PARTS & SERVICE NEWS

REF NO.	AH05538A
DATE	November 9, 2005

SUBJECT: BOLT CONNECTIONS

PURPOSE: Operator's Cab/Cab Base - Assembly and checking of mounting bolts

Assembly of a new machine:

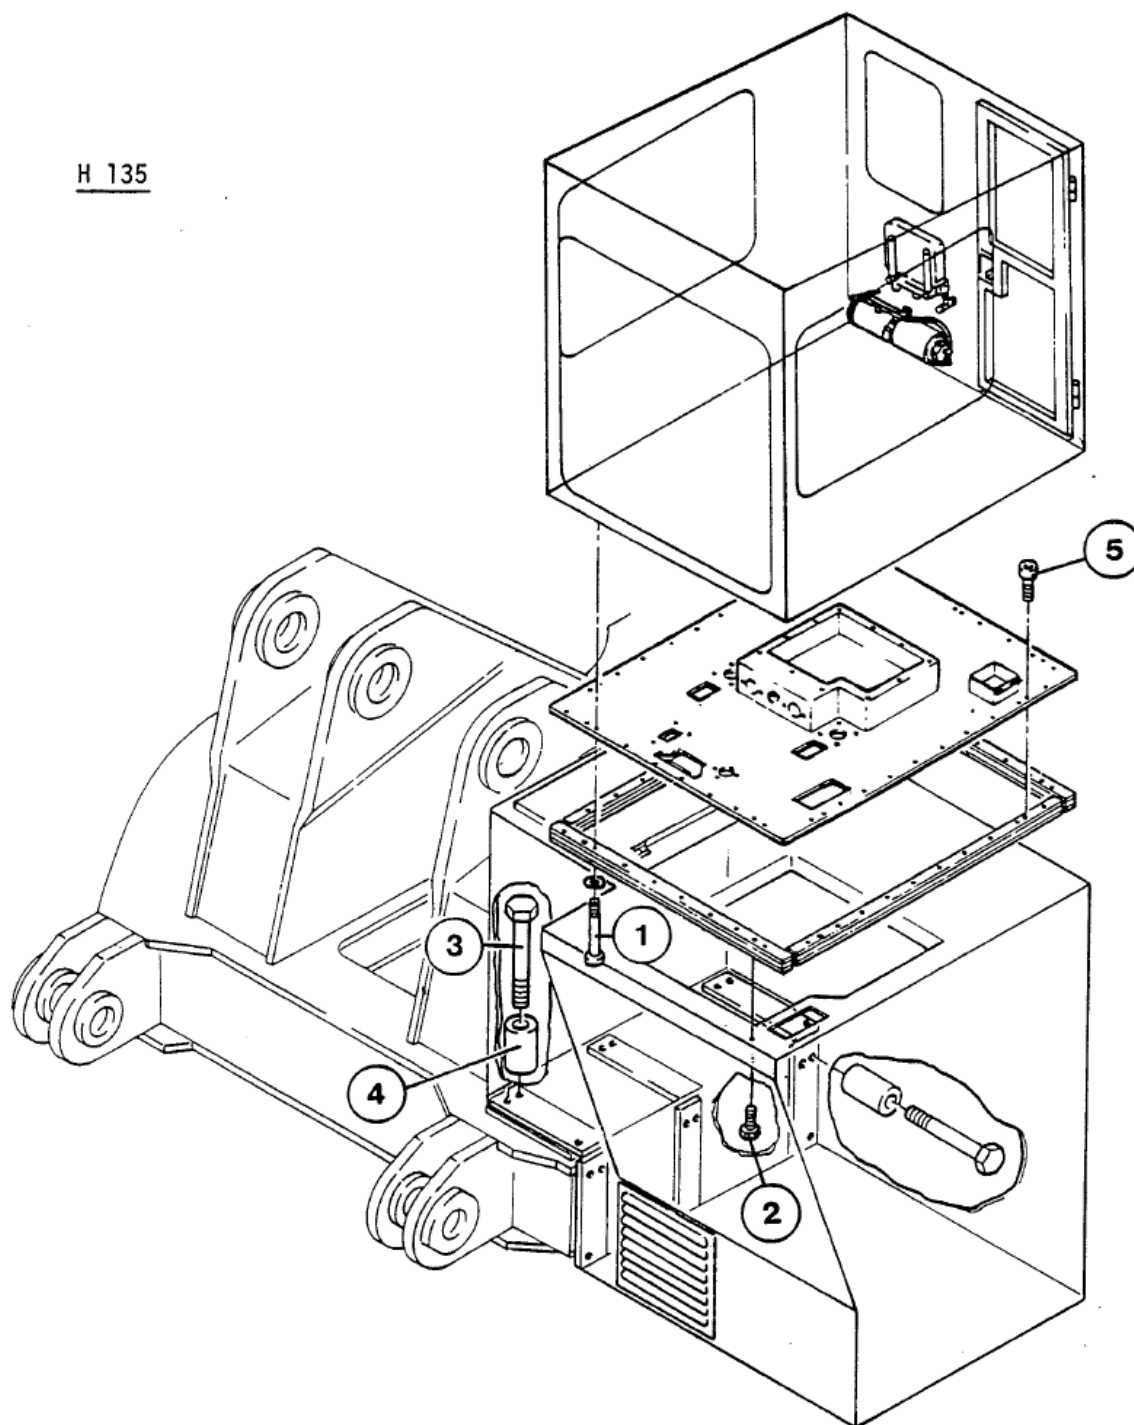
Before mounting the cab onto the base, all transport bolts, position 5 (refer to illustration), must be removed.

If the cab is placed onto the base they are no longer accessible.

H 135

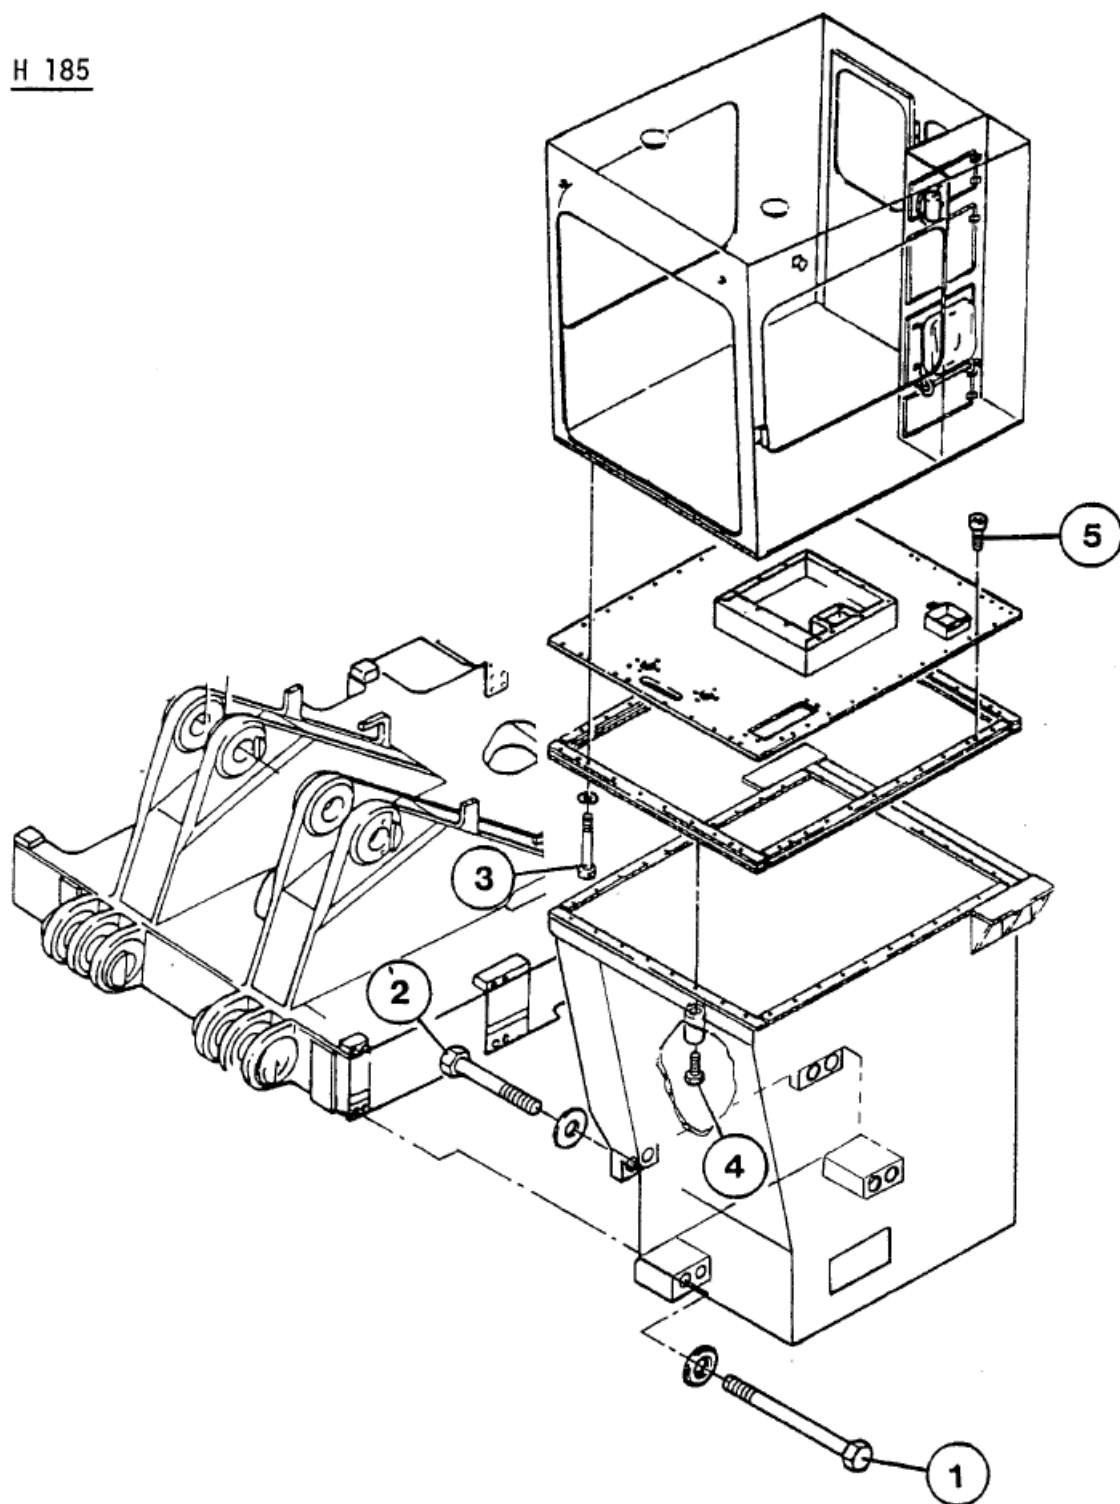
Pos.	Qty.	Designation	Part-No.	Bolt dia.	Quality	Tightening torque [Nm]
1	32	Bolt	319 433 99	M 10	8.8	43
2	36	Bolt	319 150 99	M 10	8.8	43
3	16	Bolt	308 414 99	M 20	10.9	510
4	16	Sleeve	396 089 40			
5	8	Bolt	Remove before cab mounting

H 185

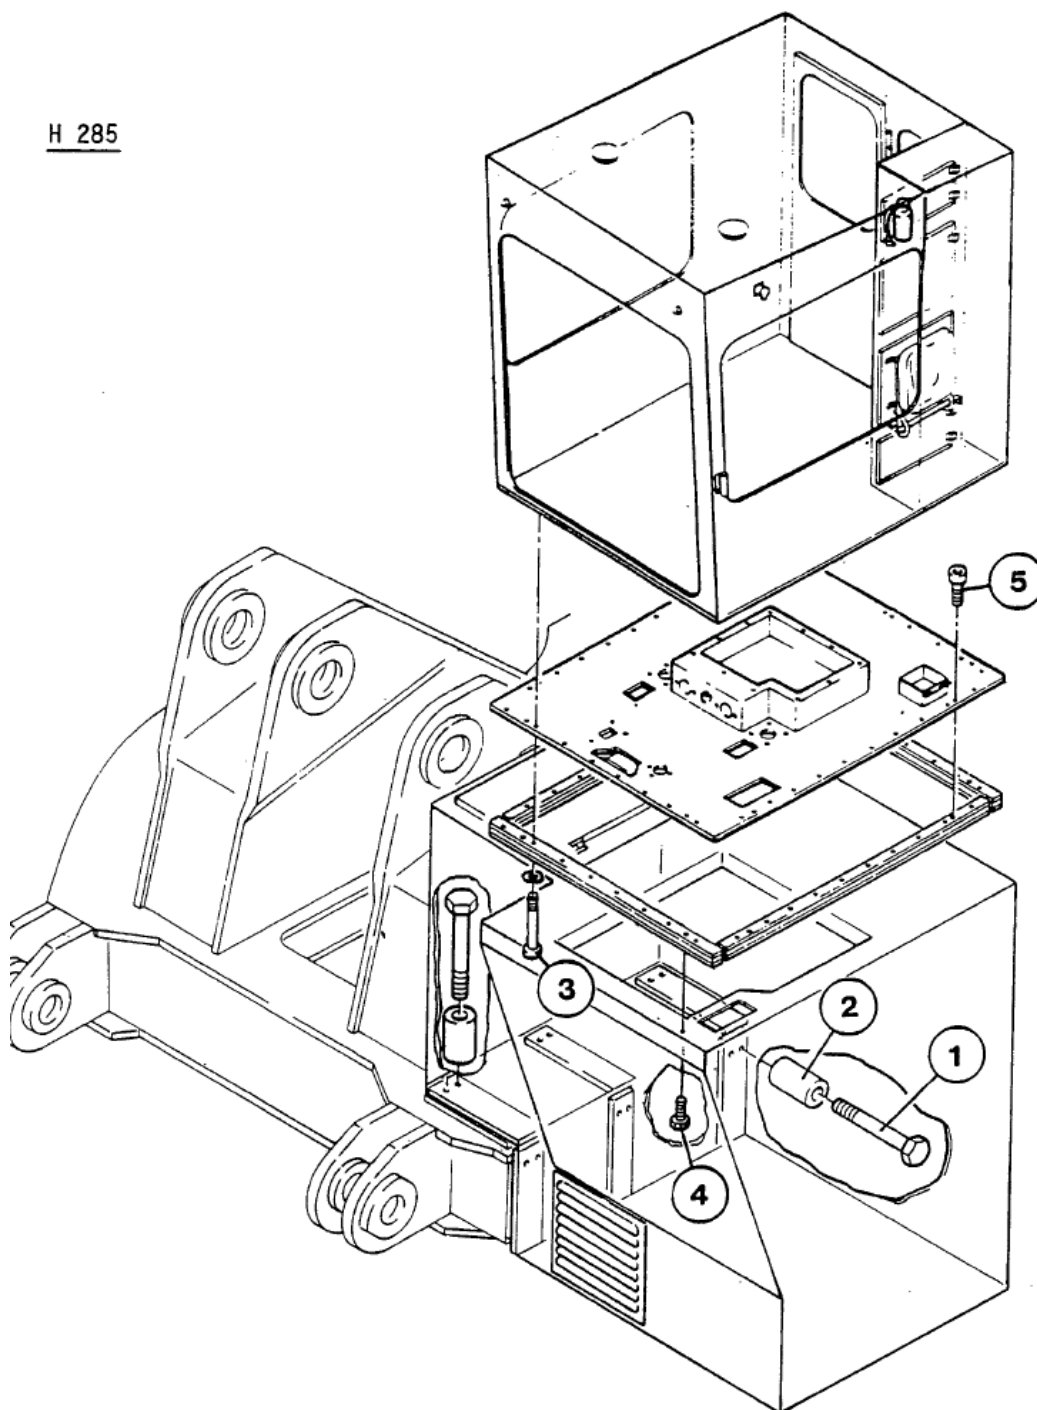
Pos.	Qty.	Designation	Part-No.	Bolt dia.	Quality	Tightening torque [Nm]
1	12	Bolt	308 886 99	M 24	10.9	880
2	12	Sleeve	385 941 40			
3	33	Bolt	319 433 99	M 10	8.8	43
4	36	Bolt	319 150 99	M 10	8.8	43
5	8	Bolt	Remove before cab mounting

H 285

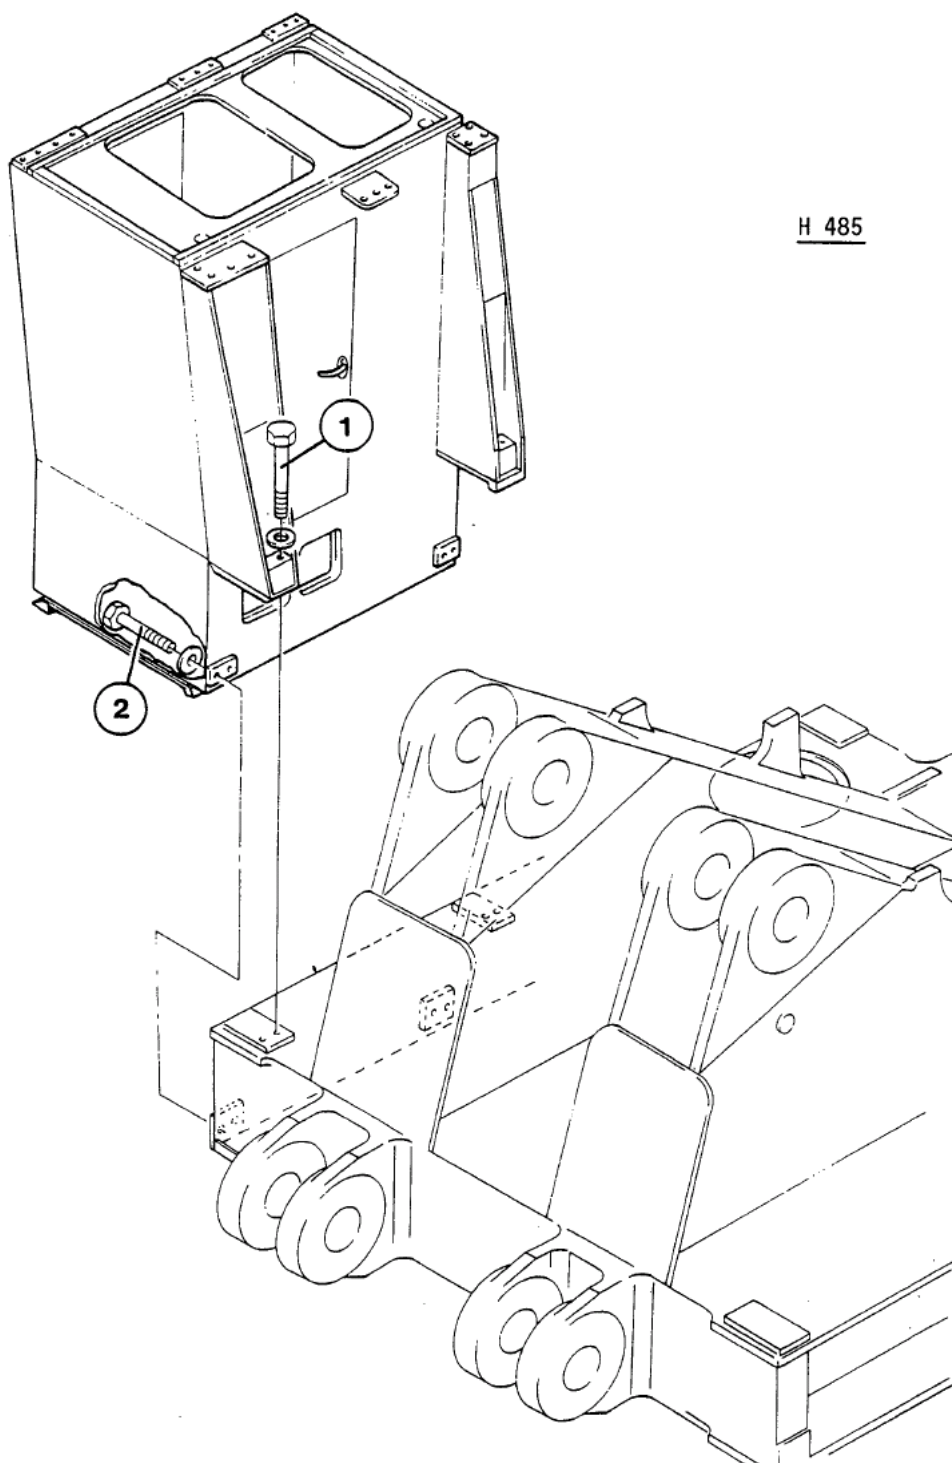
Pos.	Qty.	Designation	Part-No.	Bolt dia.	Quality	Tightening torque [Nm]
1	4	Bolt	308 341 99	M 30	10.9	1770
2	4	Bolt	308 344 99	M 30	10.9	1770
3	21	Bolt	308 885 99	M 20	10.9	510
4	36	Bolt	307 598 99	M 10	10.9	63
5	8	Bolt	Remove before cab mounting			
6	33	Bolt	319 264 99	M 10	10.9	63

H 485 (continued)

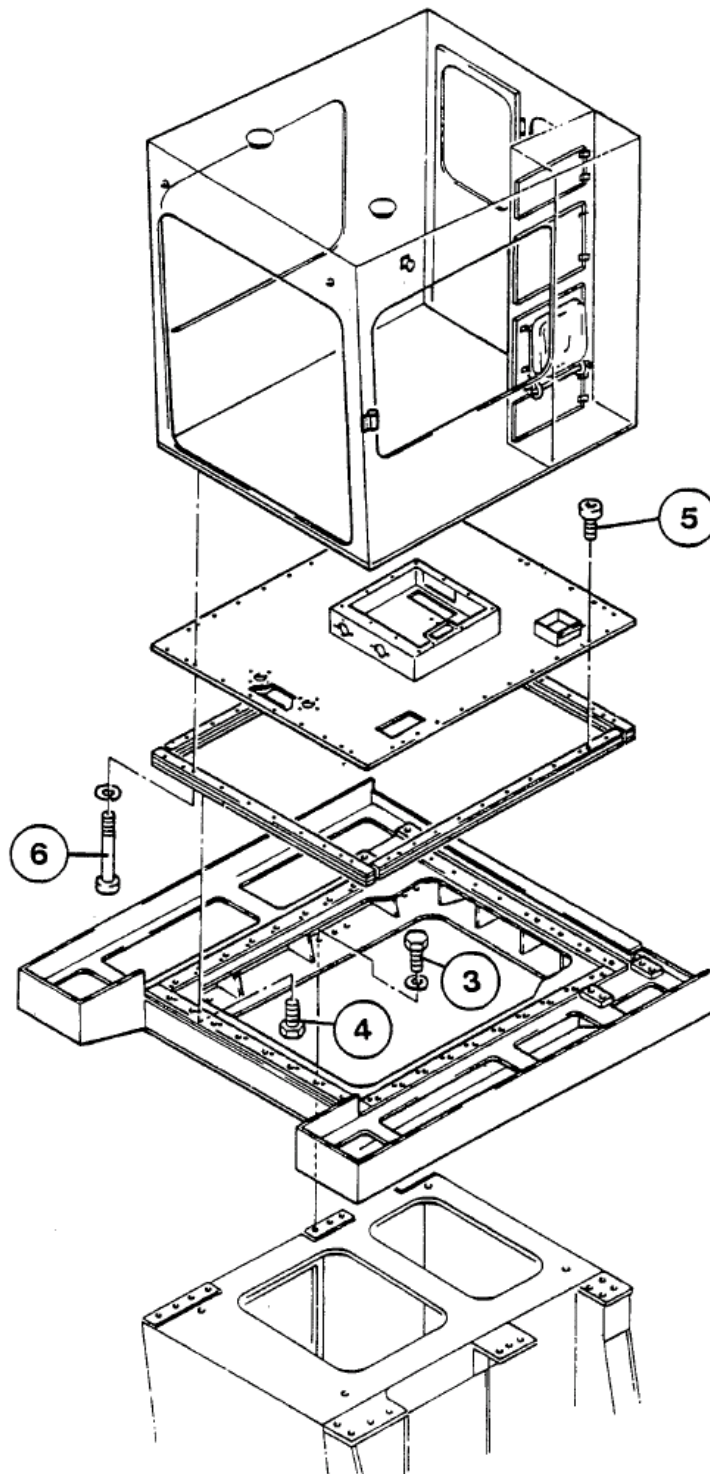
Pos.	Qty.	Designation	Part-No.	Bolt dia.	Quality	Tightening torque [Nm]
1	4	Bolt	308 341 99	M 30	10.9	1770
2	4	Bolt	308 344 99	M 30	10.9	1770
3	21	Bolt	308 885 99	M 20	10.9	510
4	36	Bolt	307 598 99	M 10	10.9	63
5	8	Bolt	Remove before cab mounting			
6	33	Bolt	319 264 99	M 10	10.9	63
